TECH NOTE 038

EXEDY REF : - 038-2

Clutch Kit including replacement Single Mass Flywheel Kit Number : GMK-7744SMF

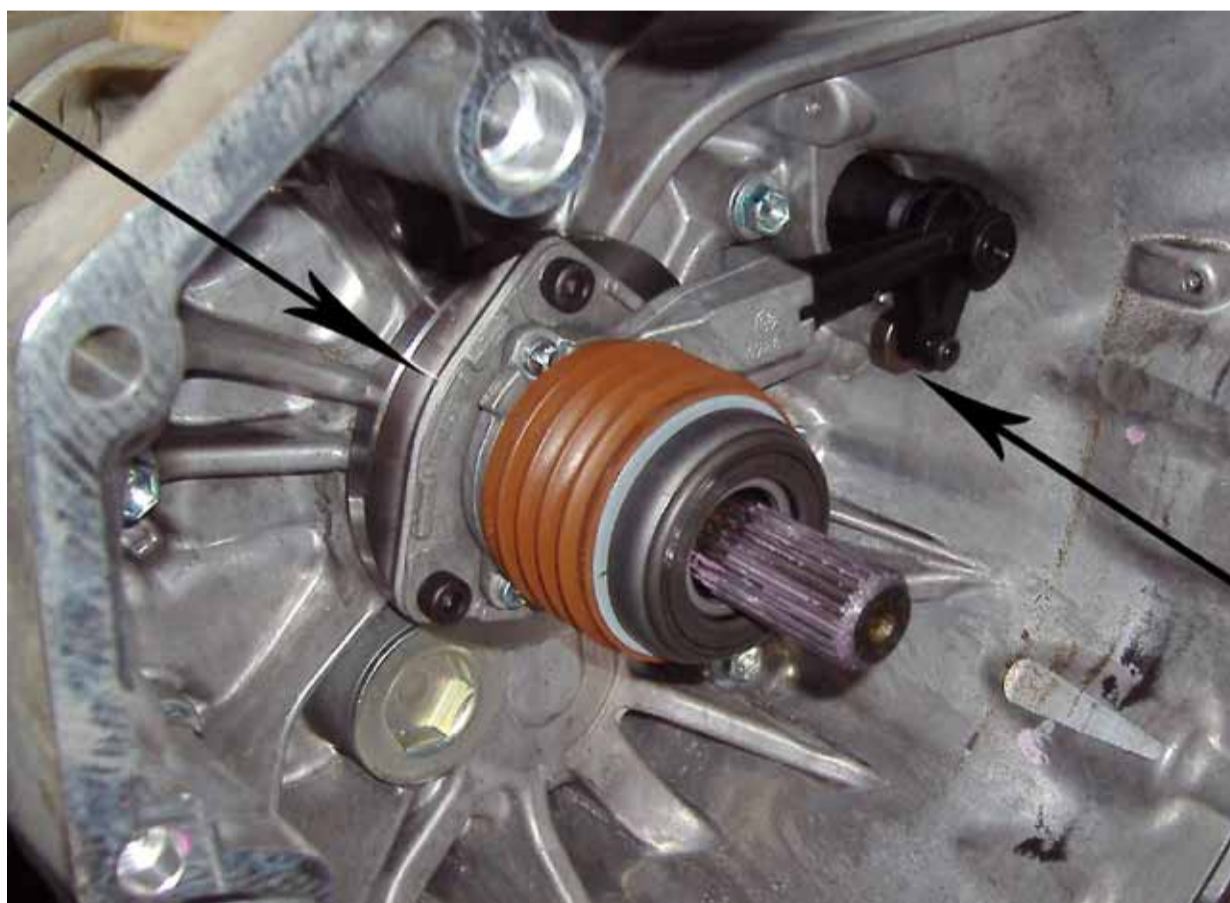
When fitting a GMK-7744SMF EXEDY clutch kit, 2 spacers are supplied that are to be installed between the C.S.C .(Concentric Slave Cylinder) and transmission front face.

These spacers are necessary to compensate for the variation in the cover assembly diaphragm finger height.

Suitable bolts are also included in the clutch kit.
